## PRODUCT CHANGE NOTIFICATION

#PCN-DC-KLKJ-15

Part#	Type Description
0707086	HDFK 4
0707866	HDFK 4 GNYE
0709026	HDFKV 4
0714011	HDFK 4/Z
3073306	UW 4
3073319	UW 4/S
3073380	UWV 4

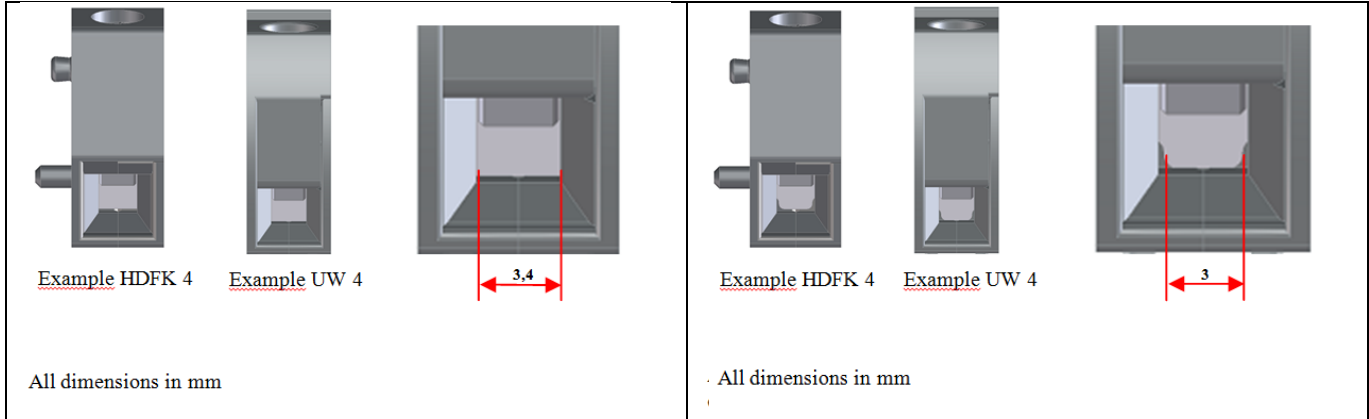
Upon tooling investigation it was found that we could minimize cost increases on this product line by utilizes a metal clamping sleeve used on our rail mounted terminal blocks. Because of this change there is a slight narrowing of the change at the bottom of the wire entry. See images below.

This change does not affect the wire gauge or any other technical data.
